TITLE **91-00-00-50Z-61**
UHF FILTER

ITS CORPORATION				REV	ECN	DATE	APV
REV	ECN	DATE	APV	THIS PRINT IS THE PROPERTY OF ITS CORP. IT SHALL NOT BE COPIED WITHOUT PERMISSION.			
				TITLE			
MATERIAL				SCH, 4 WAY SPLITTER BOARD (1227-1312)			
FINISH				DWN	SJM	2/16/94	DWG. NO.
				CHK	DWB	8-27-94	1227-3312
				REL	DWB	8-28-94	0
				SCALE ---		SHEET 1 OF 1

ITS CORPORATION			
THIS PRINT IS THE PROPERTY OF ITS CORP. IT SHALL NOT BE COPIED WITHOUT PERMISSION.			
DATE	APV	TITLE SCHEMATIC, DUAL PEAK DET BD., SINGLE SUPPLY (1227-1333)	
REV	ECN	DWN	PJK
1	7735	8/31/94	12/19/94
2	7735	12/19/94	12/19/94
3	7735	12/19/94	12/19/94
4	7735	12/19/94	12/19/94
5	7735	12/19/94	12/19/94
6	7735	12/19/94	12/19/94
7	7735	12/19/94	12/19/94
8	7735	12/19/94	12/19/94
9	7735	12/19/94	12/19/94
10	7735	12/19/94	12/19/94
11	7735	12/19/94	12/19/94
12	7735	12/19/94	12/19/94
13	7735	12/19/94	12/19/94
14	7735	12/19/94	12/19/94
15	7735	12/19/94	12/19/94
16	7735	12/19/94	12/19/94
17	7735	12/19/94	12/19/94
18	7735	12/19/94	12/19/94
19	7735	12/19/94	12/19/94
20	7735	12/19/94	12/19/94
21	7735	12/19/94	12/19/94
22	7735	12/19/94	12/19/94
23	7735	12/19/94	12/19/94
24	7735	12/19/94	12/19/94
25	7735	12/19/94	12/19/94
26	7735

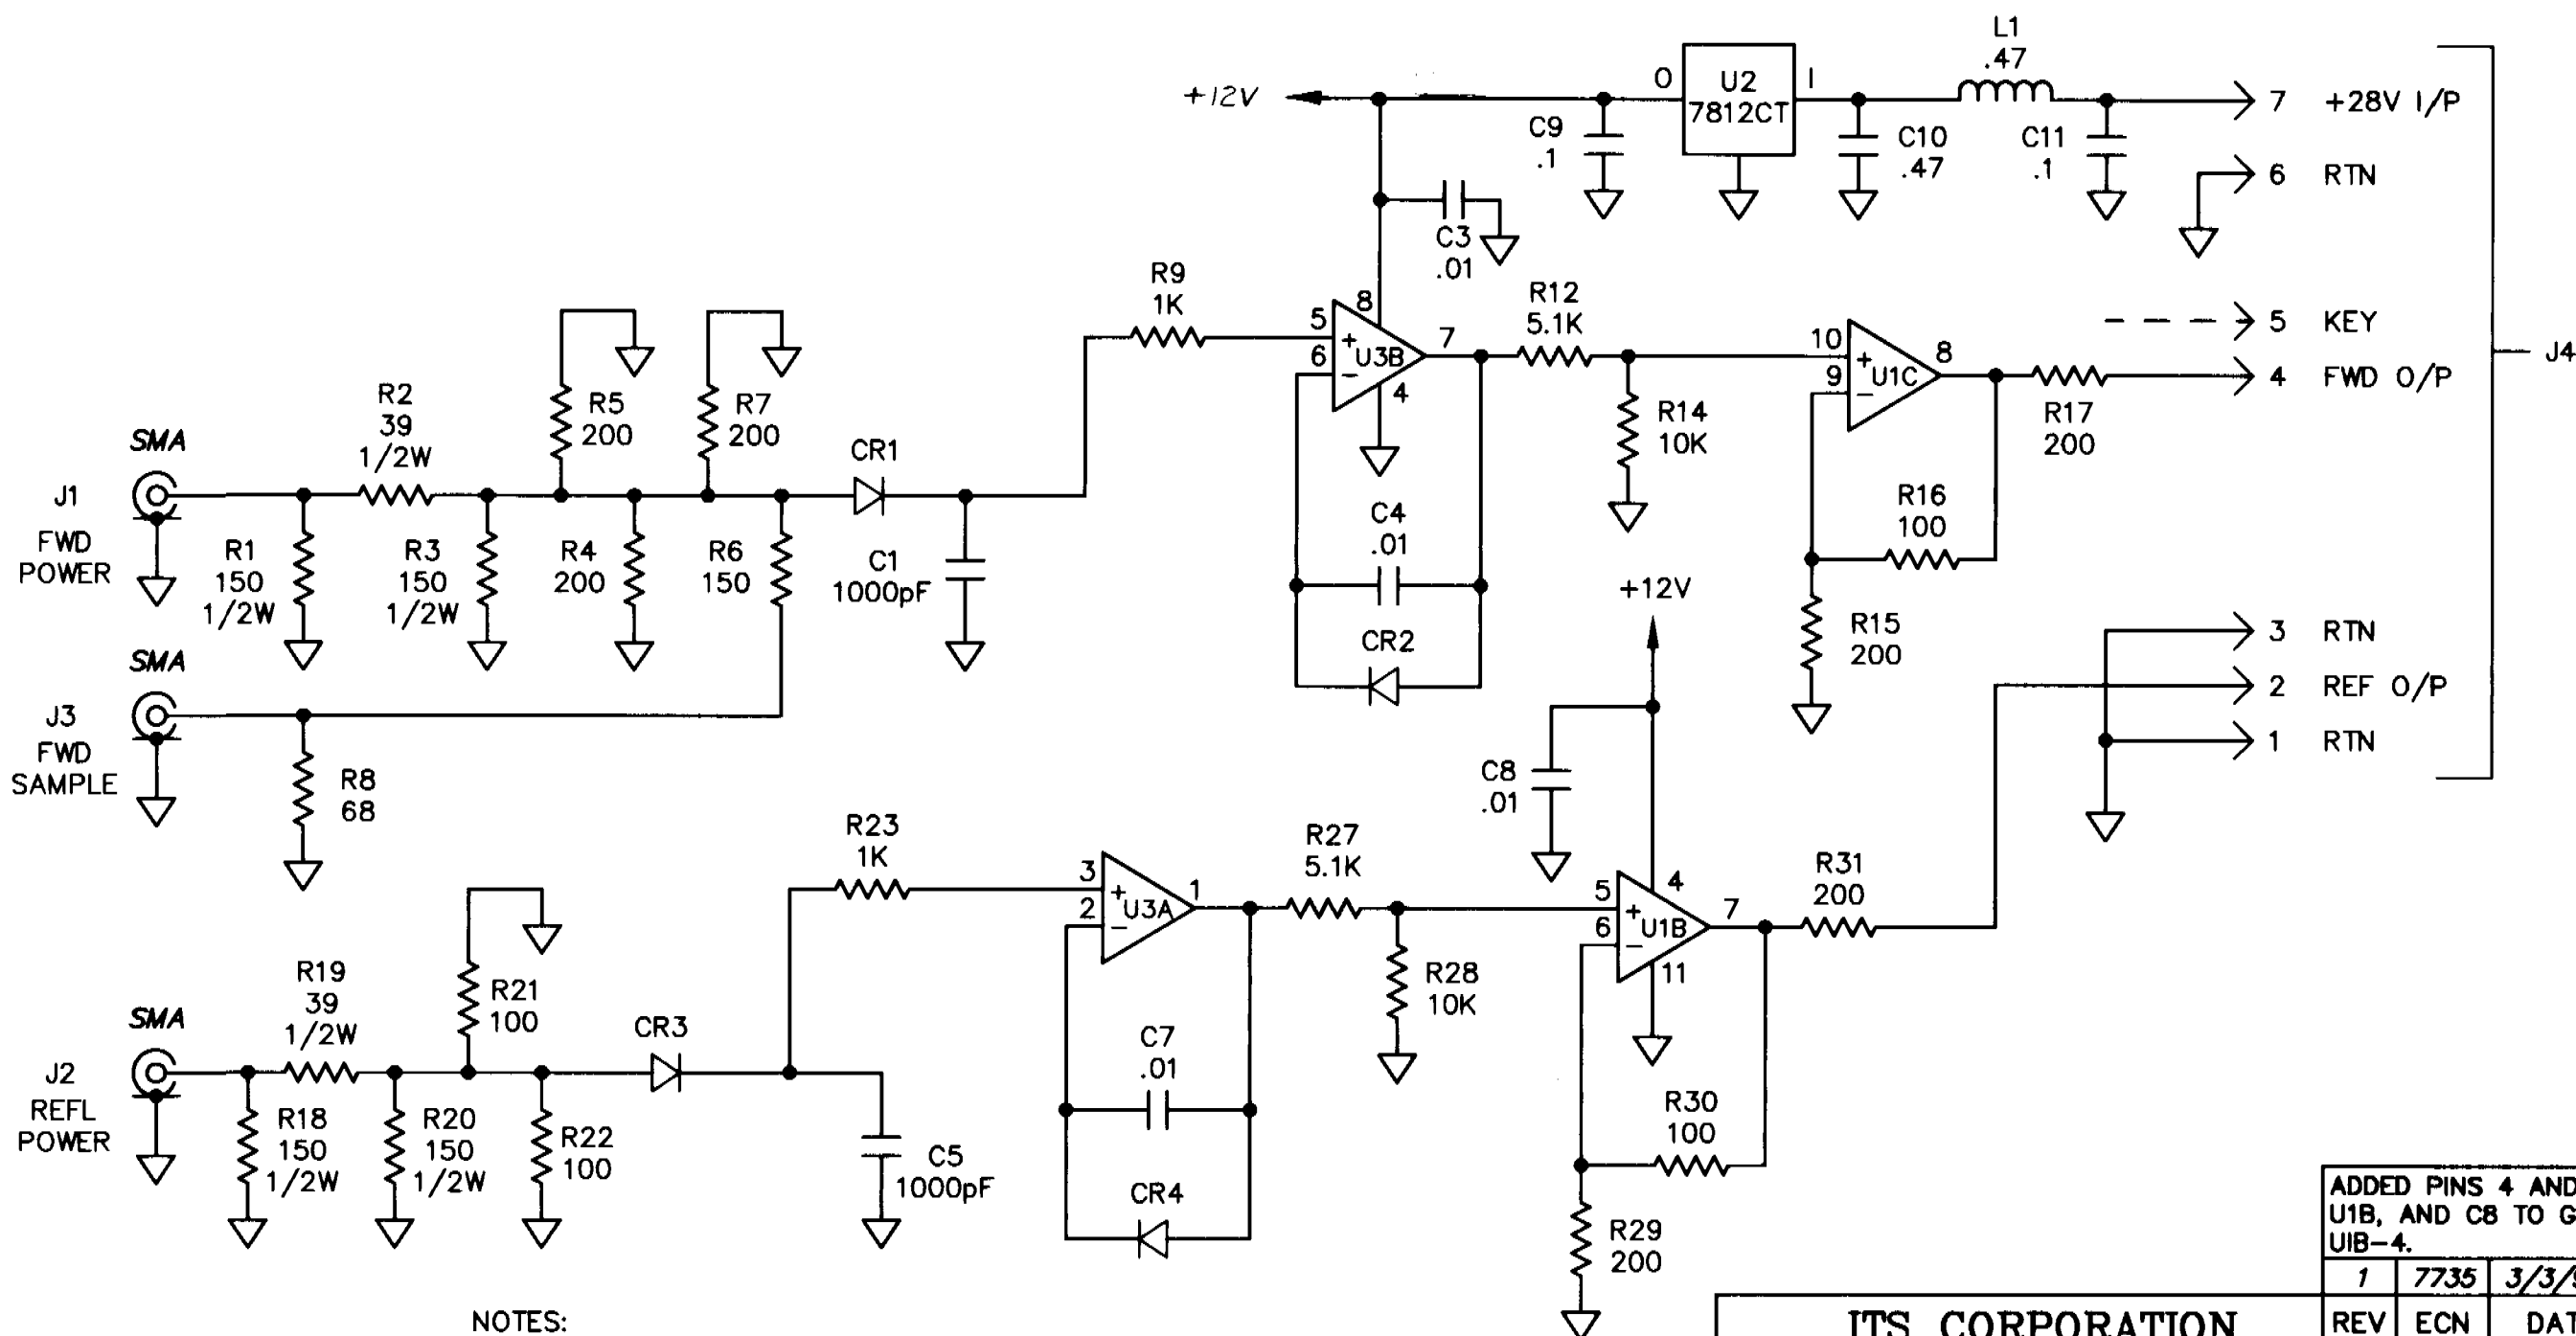
ADDED PINS 4 AND 11 TO U1B, AND C8 TO GND FROM UIB-4.			
1	7735	3/3/95	RE
REV	ECN	DATE	APV

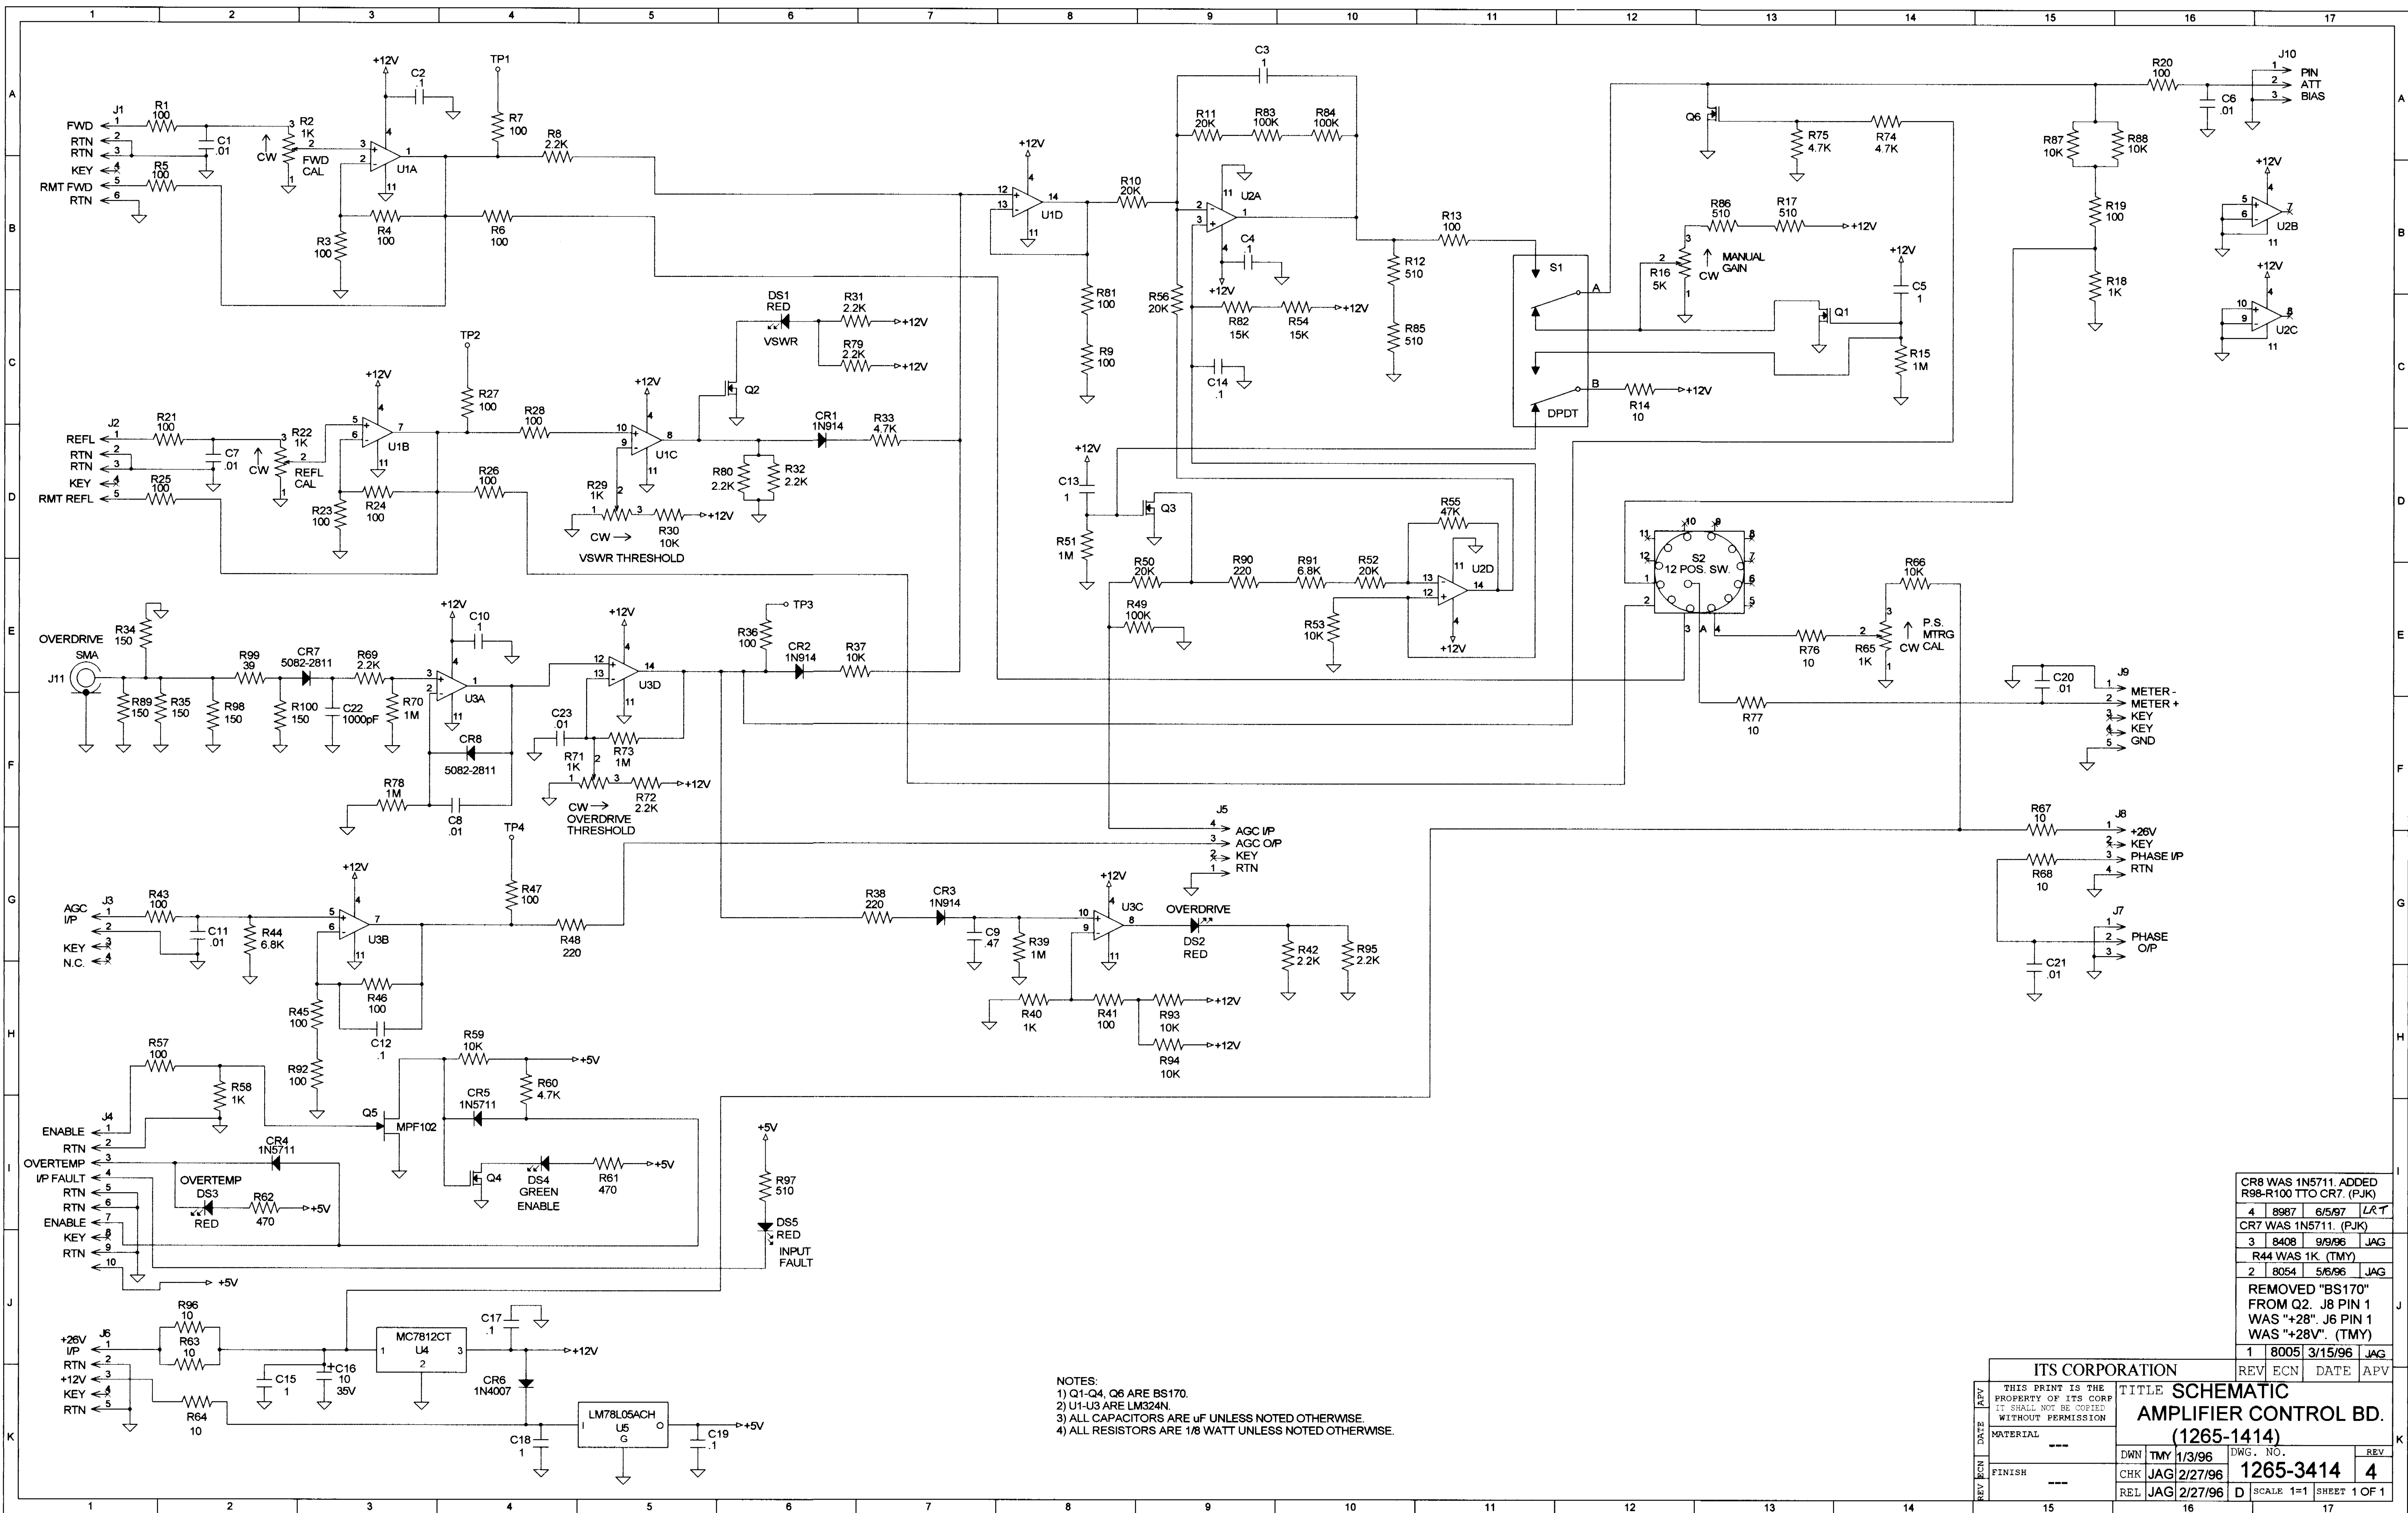
CR8 WAS 1N5711. ADDED
R98-R100 TTO CR7. (PJK)

CR7 WAS 1N5711. (PJK)

R44 WAS 1K. (TMY)

REMOVED "BS170"
FROM Q2. J8 PIN 1
WAS "+28". J6 PIN 1
WAS "+28V". (TMY)

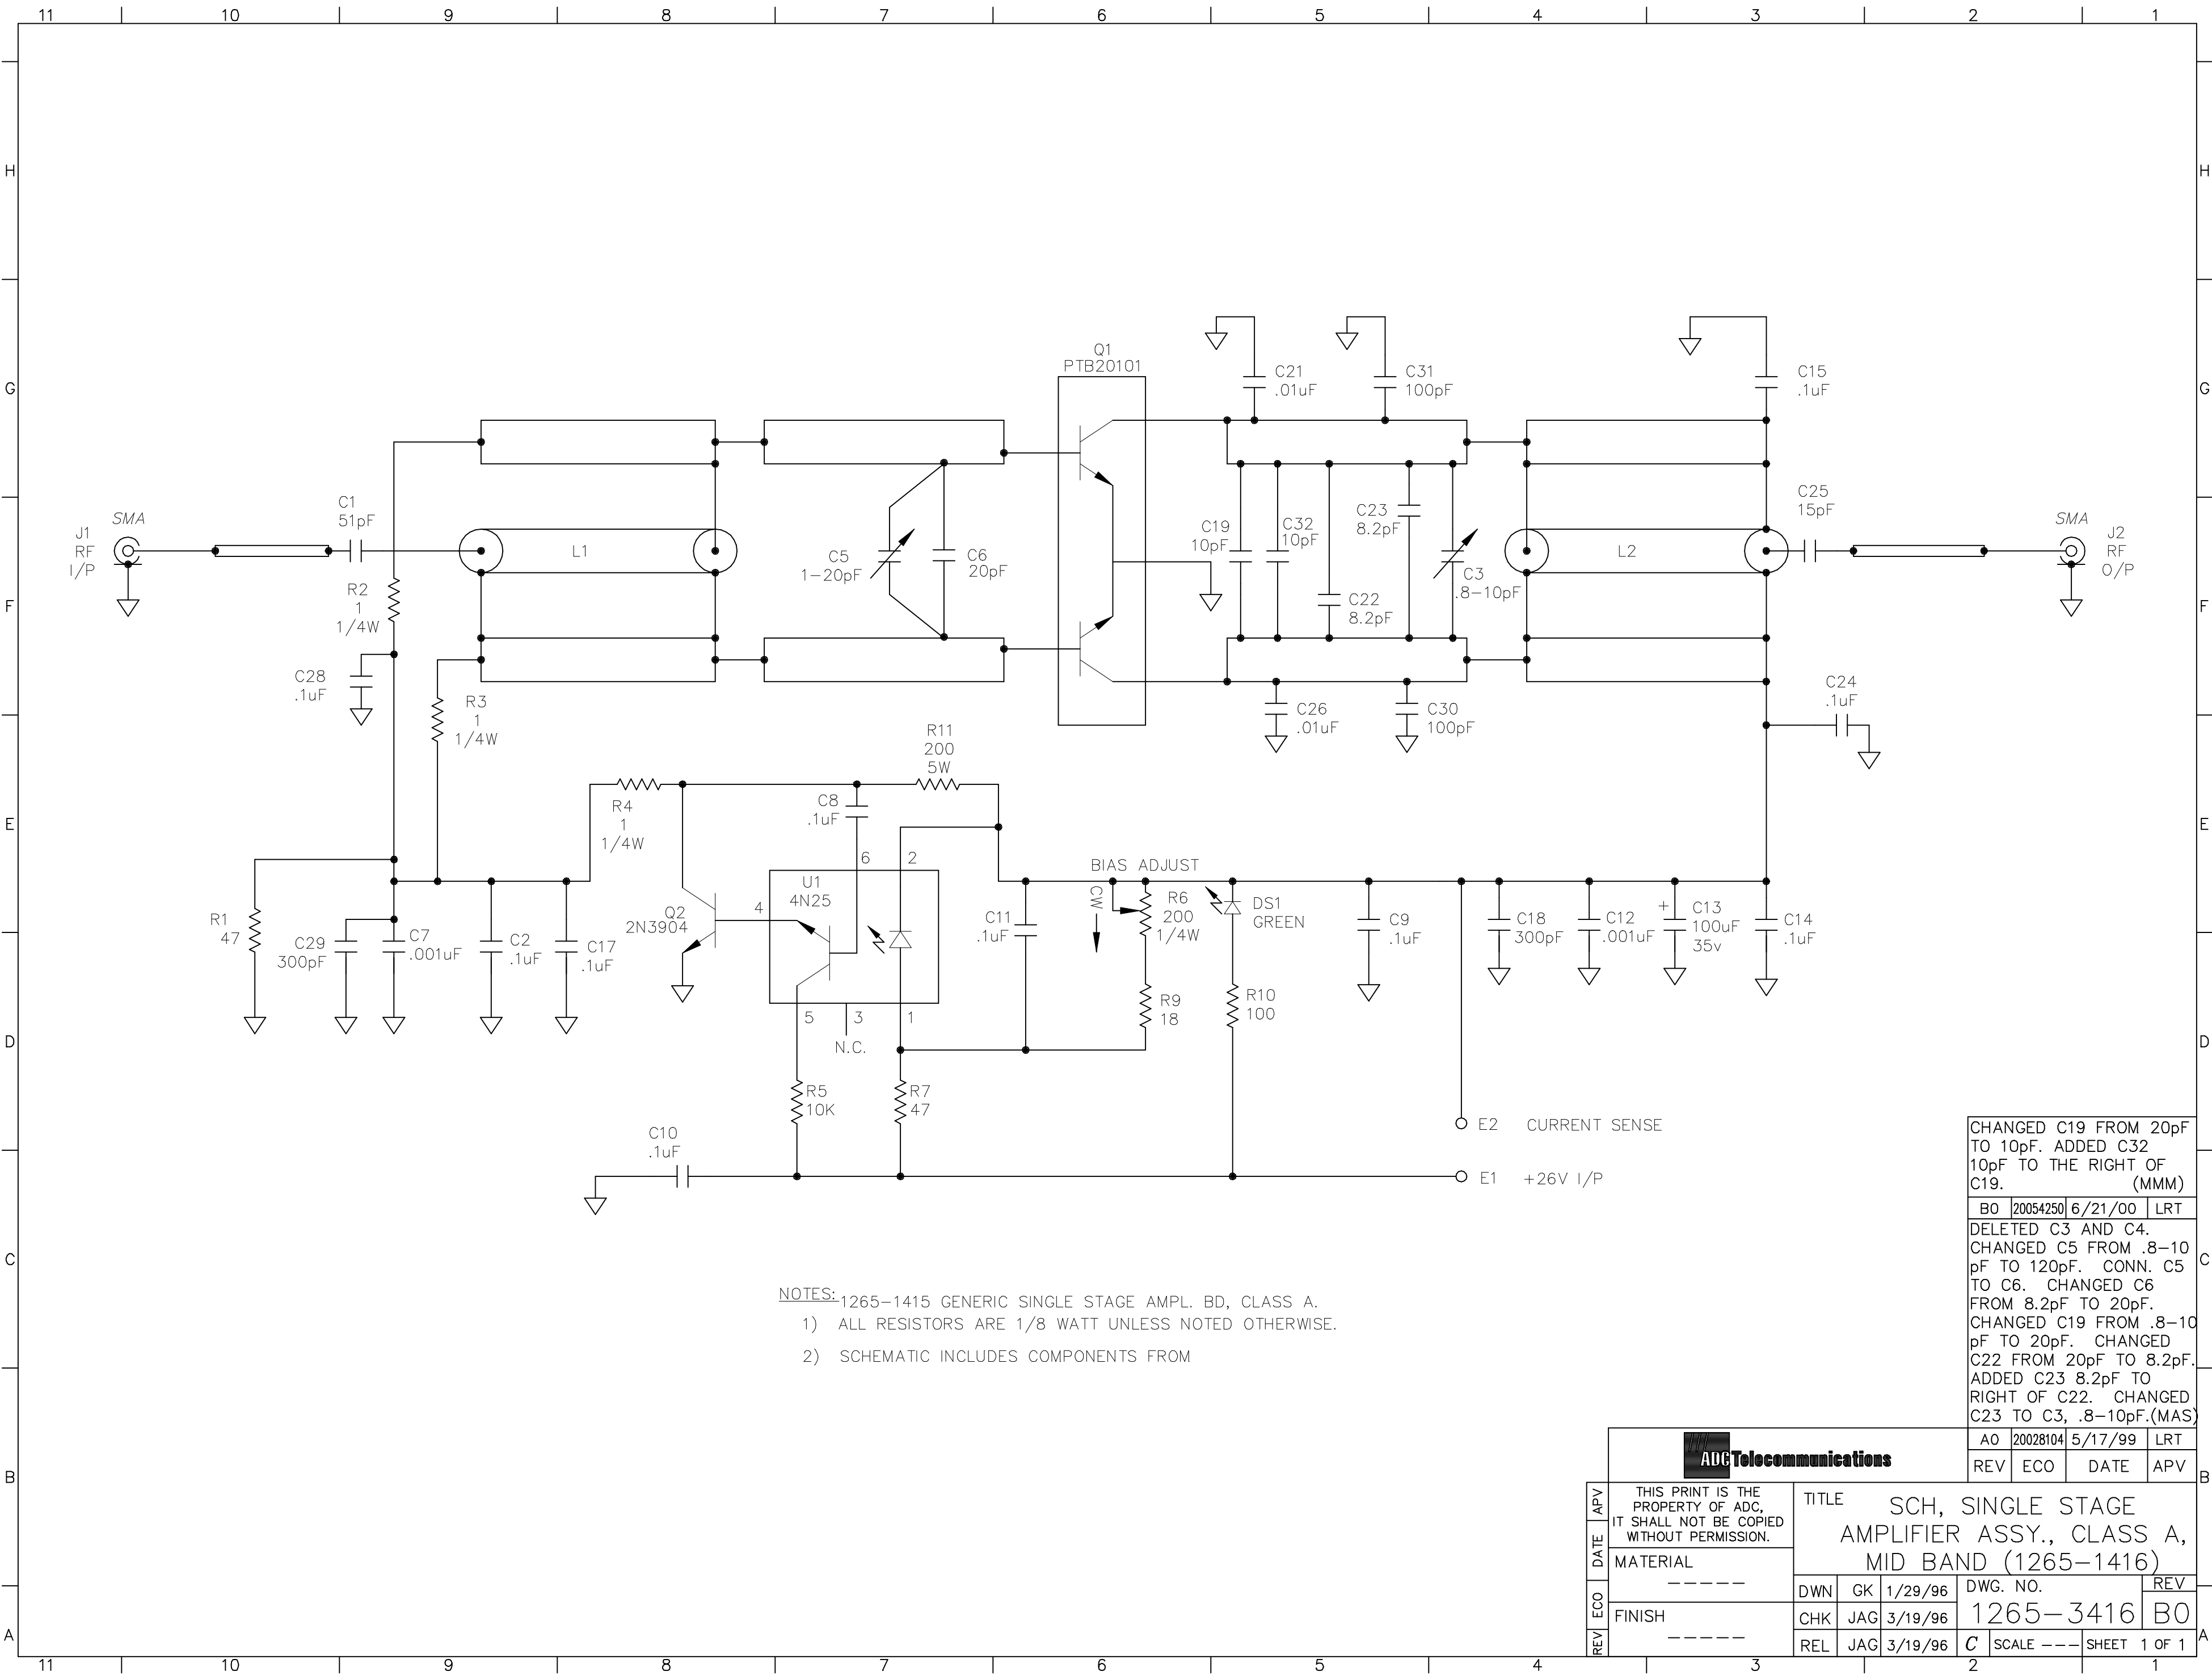
CHANGED C19 FROM 20pF TO 10pF. ADDED C32 10pF TO THE RIGHT OF C19. (MMM)
B0 20054250 6/21/00 LRT
DELETED C3 AND C4. CHANGED C5 FROM .8-10 pF TO 120pF. CONN. C5 TO C6. CHANGED C6 FROM 8.2pF TO 20pF. CHANGED C19 FROM .8-10 pF TO 20pF. CHANGED C22 FROM 20pF TO 8.2pF. ADDED C23 8.2pF TO RIGHT OF C22. CHANGED C23 TO C3, .8-10pF.(MAS)
